June 14, 2021

## **Addendum No. 1:**

### **Project: PSFA PROJECT NO: P19-009 – Mesa Middle School Renovations and Addition – Roswell Independent School District and PSFA**

**G-005**  
 COPYRIGHT 2019 HUITT-ZOLLARS INC.

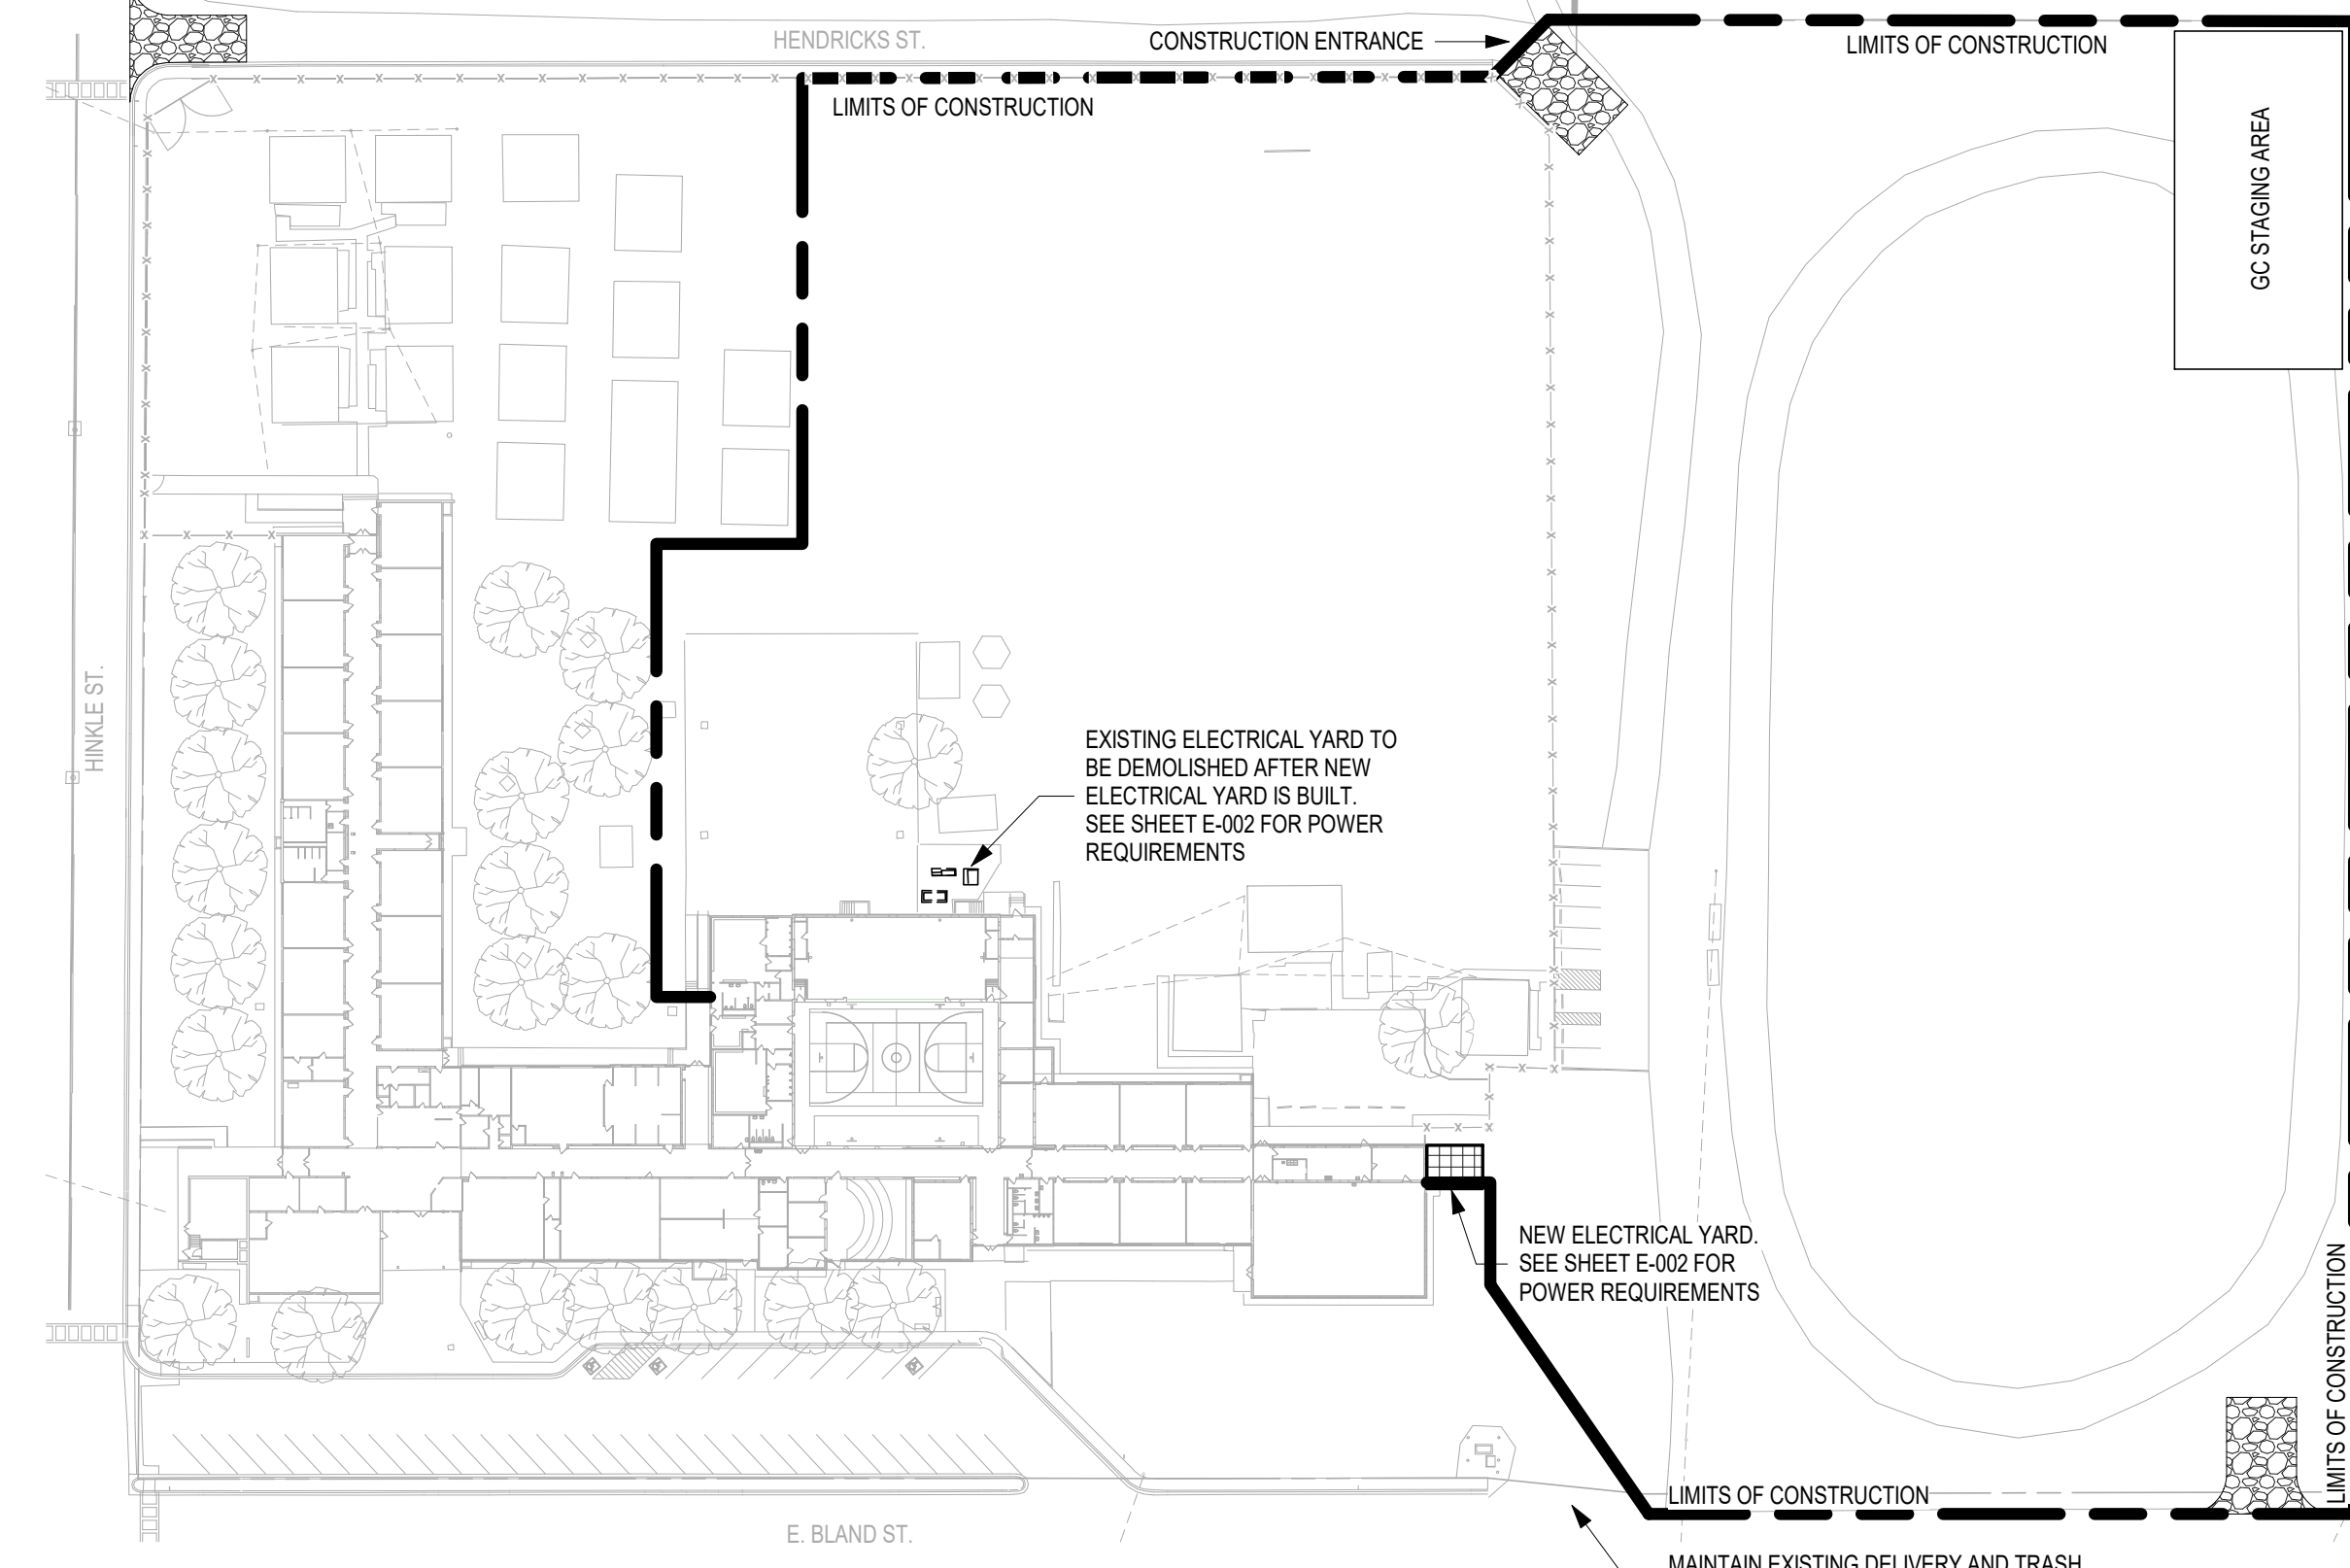
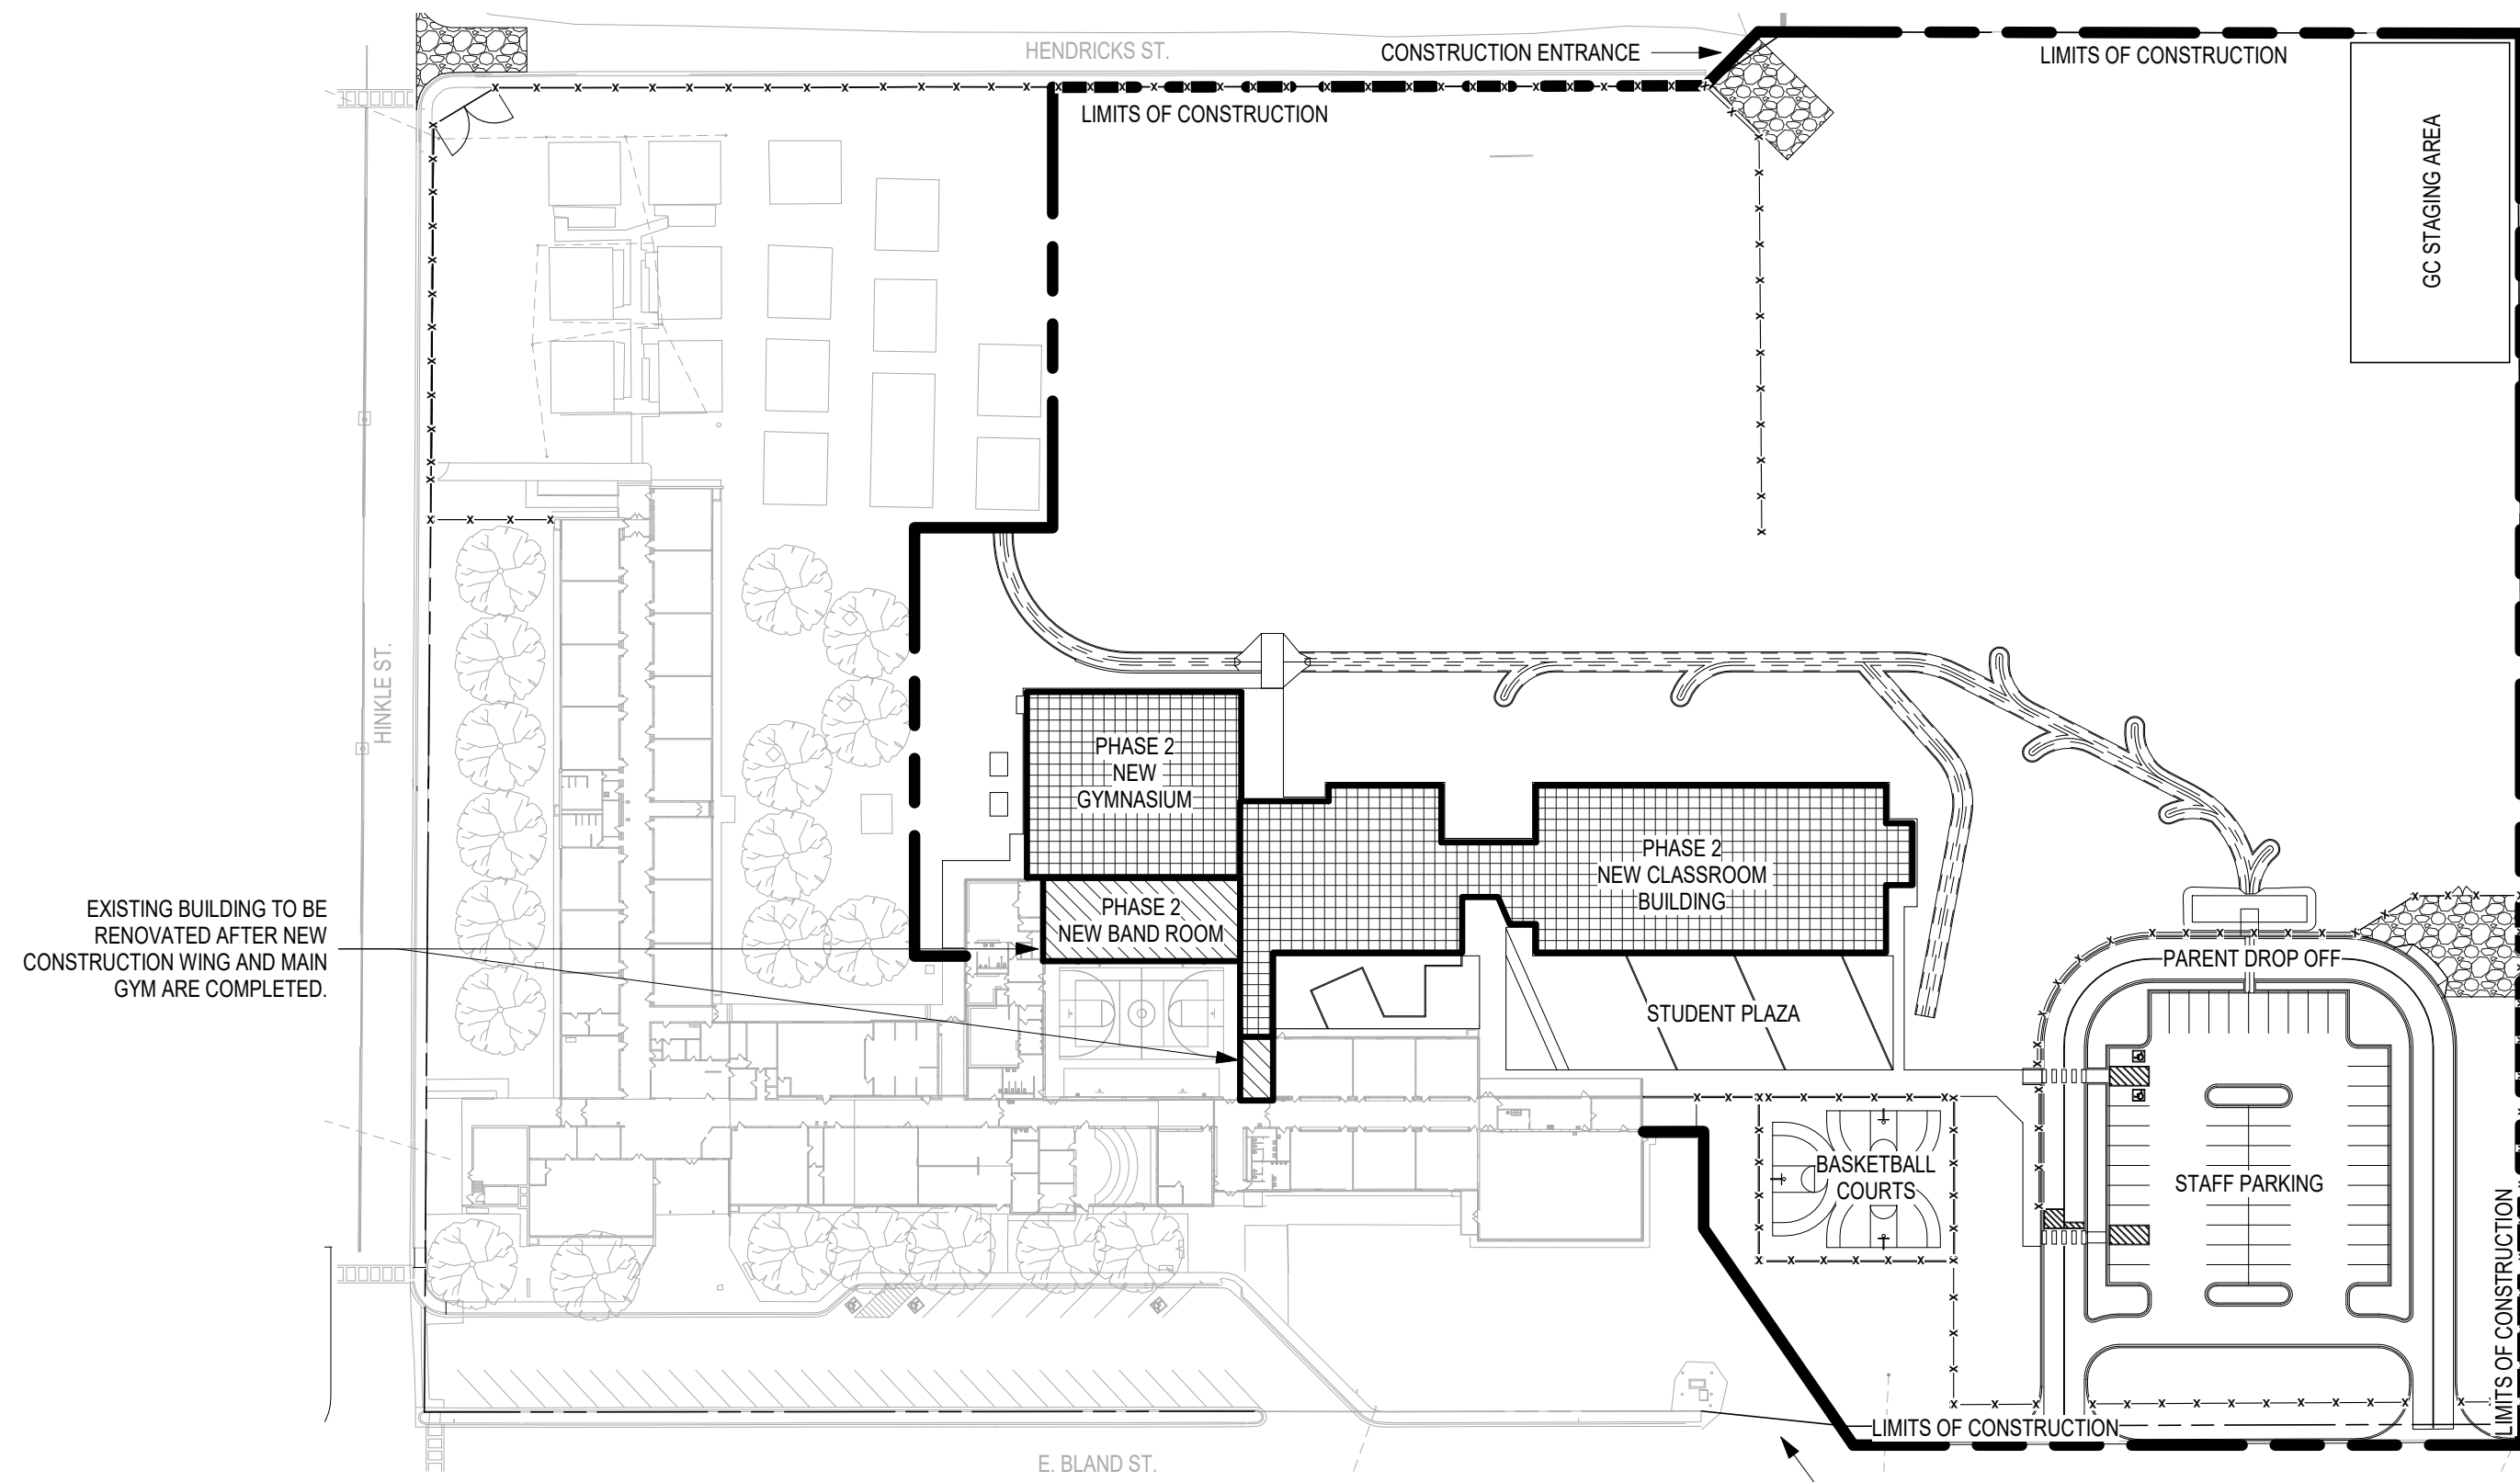
10. *G-005 specifies "Existing Cafeteria to be renovated during summer." Keeping in mind the anticipated award date of July 14, what is the deadline for completion of this portion of work?*

17. *Phasing Plan B2 "Phase 2 Demolition" indicates "corridor to remain accessible to students." Will this corridor need to remain open throughout construction?*
  - a. **Yes, path to cafeteria to remain open during construction.**
18. *How long will it take to relocate the school program to portables before Phase 2A commences?*
  - a. **No Phase 2A shown on Sheet G-005. Clarify question.**

- a. **See updated G-005 and G-005A Phasing Plans in this Addendum.**
11. *Is the General Contractor responsible for the abatement of existing facilities?*
